C-900 - ADDENDUM

Addendum No. 2

Date:	<u>March 27, 2019</u>
Issued To:	<u>Plan Holders</u>
From:	<u>Alan Plummer Associates</u>
Project:	<u>Wastewater Treatment Plant Expansion</u>

Village of Taos Ski Valley Wastewater Treatment Plant Expansion Pre-Bid Meeting Agenda March 18, 2019 – 1:00 PM

PROPOSED TREATMENT BUILDING PLAN

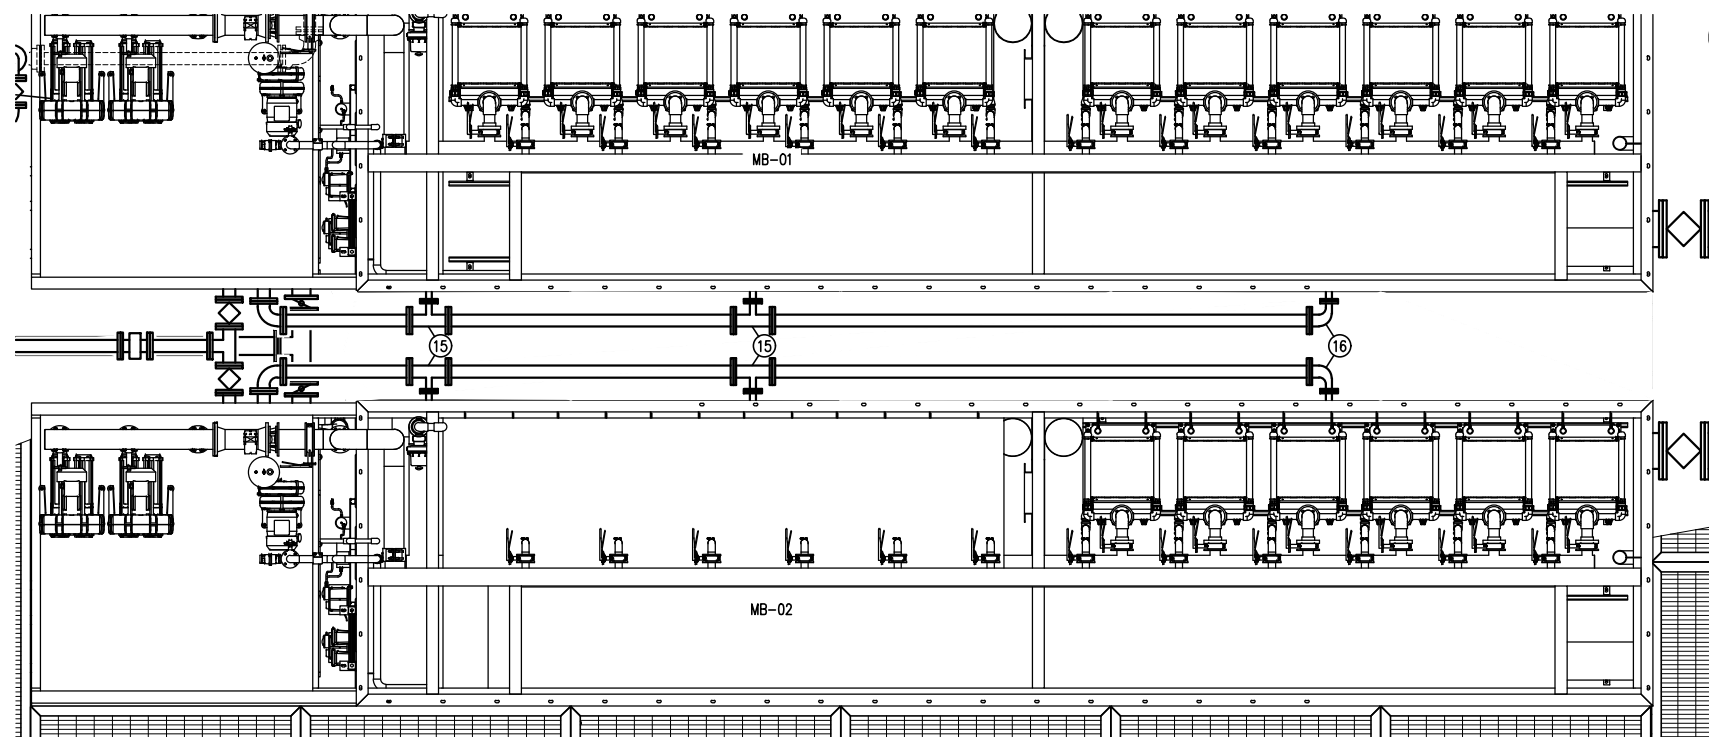
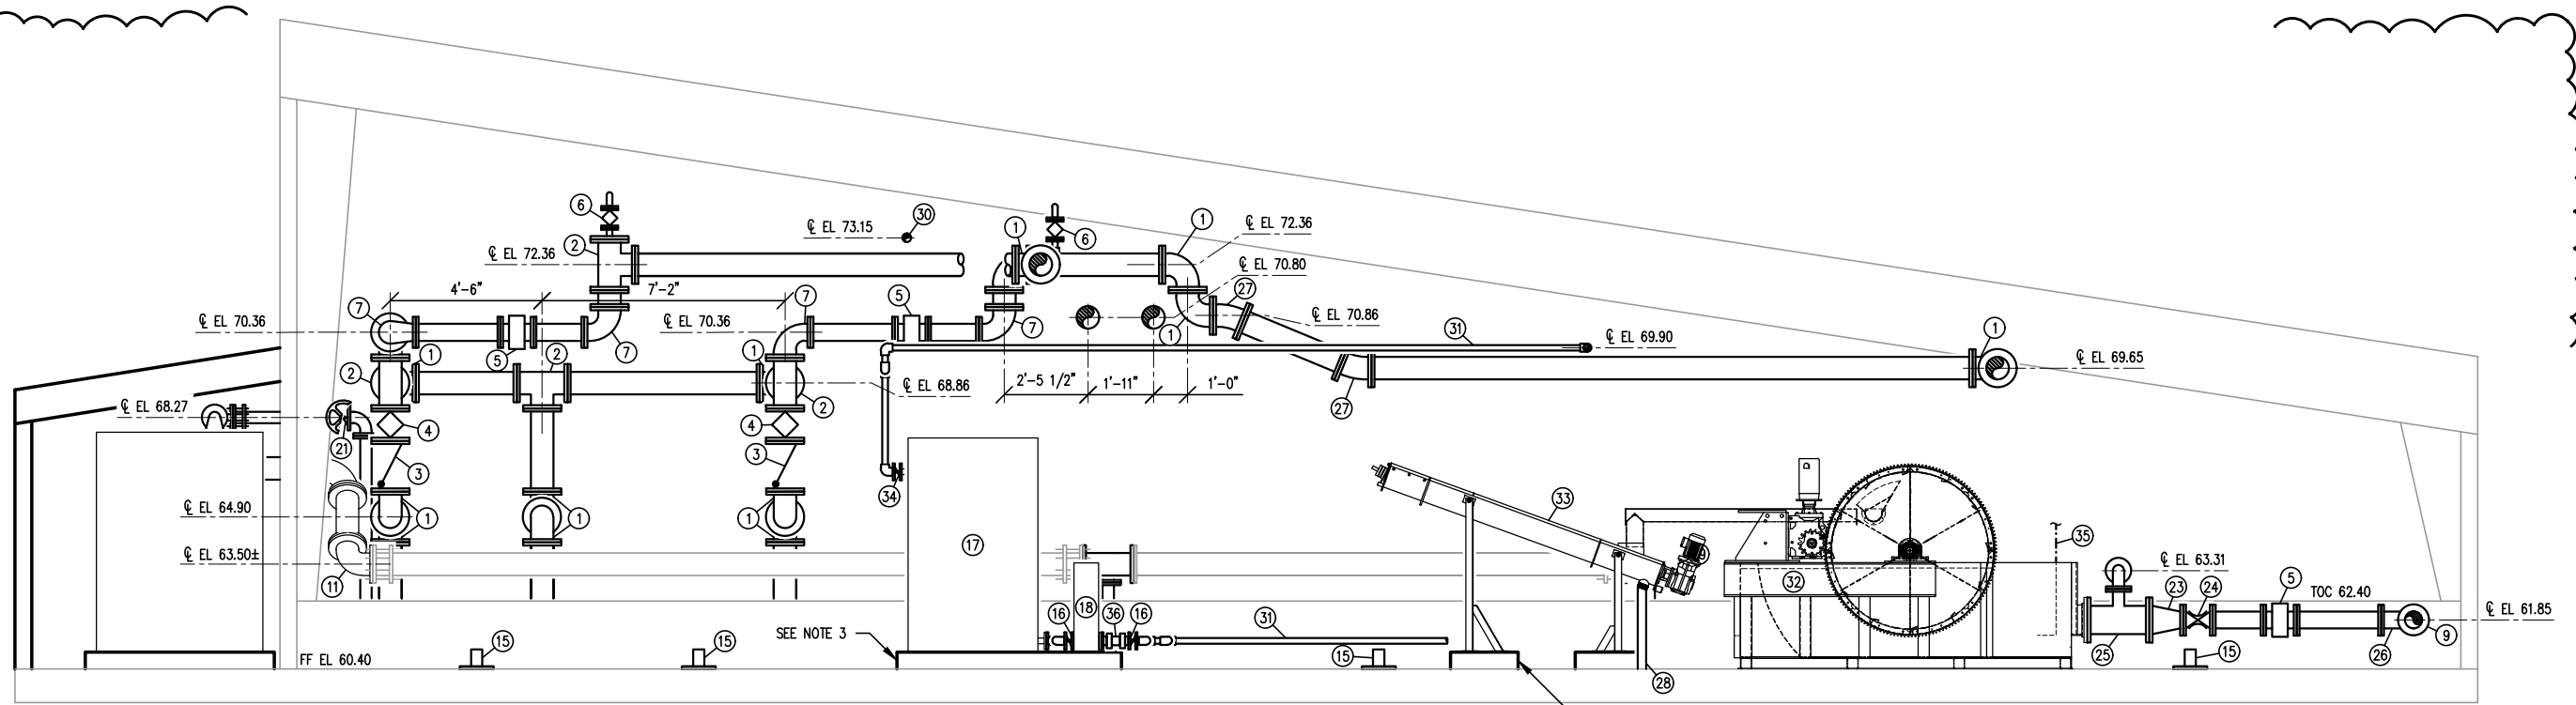
2. Sheet No. P1-04: PROPOSED TREATMENT BUILDING PLAN
 - a. **Add** Note 3 – "3. Process Piping Below Building Foundation/Slab Shall Be Constructed Using Concrete Encasement. See Structural Detail."

SECTION B
3/16"=1'-0" P1-02

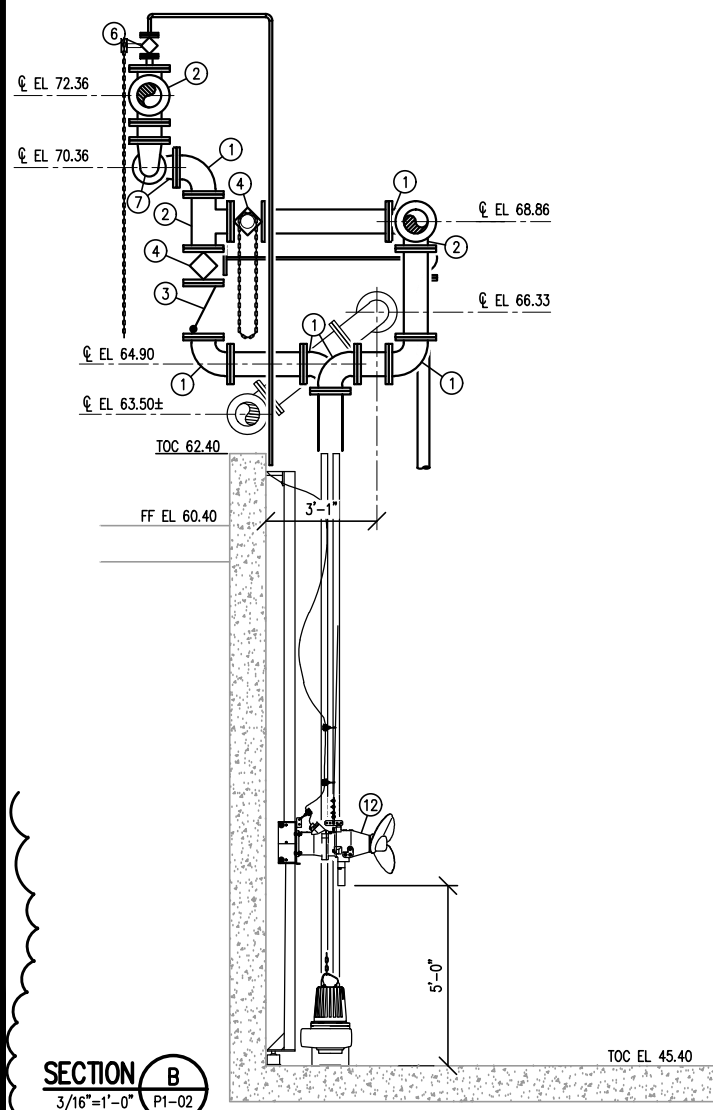
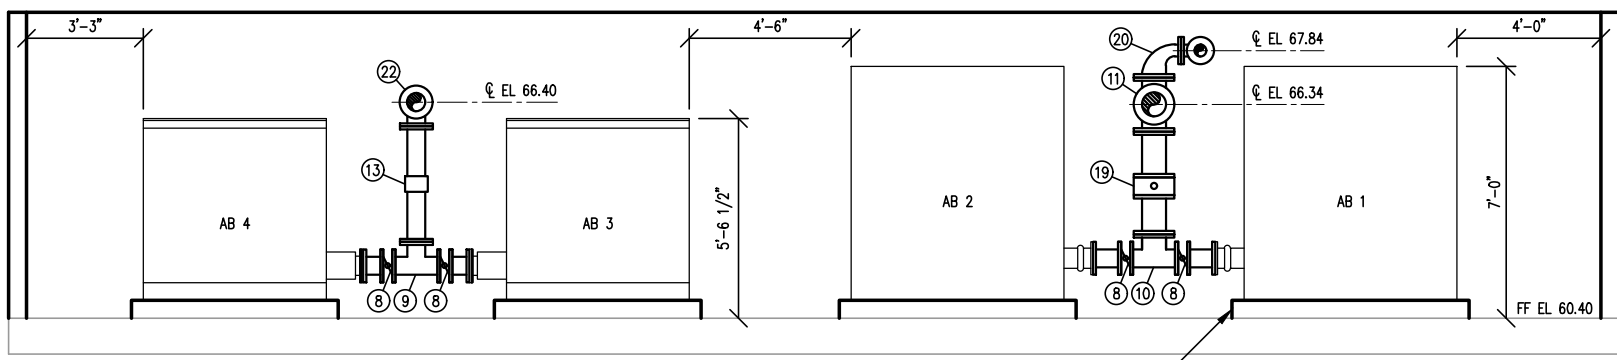
1. Response: The valve will be provided by the Contractor. The Tag for valve as V-050113.
- L. Plan Sheet P3-01, Section C, Note #13: Note calls for Expansion Joint on Process Air Pipe, symbol appears to be a Dresser Coupling. Is this actually an Exp joint? If so what is this Exp Joint's Tag #s on the P&IDs? Is this Exp Jt. provided by the MBR Supplier? If not please provide a reference to correct specification.

1. Response: Expansion Joint EJ-090105 is not provided by the MBR Supplier. Refer to revised Sheet No.'s P3-01 (specified in Equipment Note 13) and I0-14 included in this Addendum.

3. Sheet No. P3-01: EXISTING TREATMENT BUILDING SECTIONS
 - a. Equipment Note 13 – **Add** "MFR: Proco Products; Model: Proco Style 231 EPDM."
 4. Sheet No. P3-02: EXISTING TREATMENT BUILDING SECTIONS
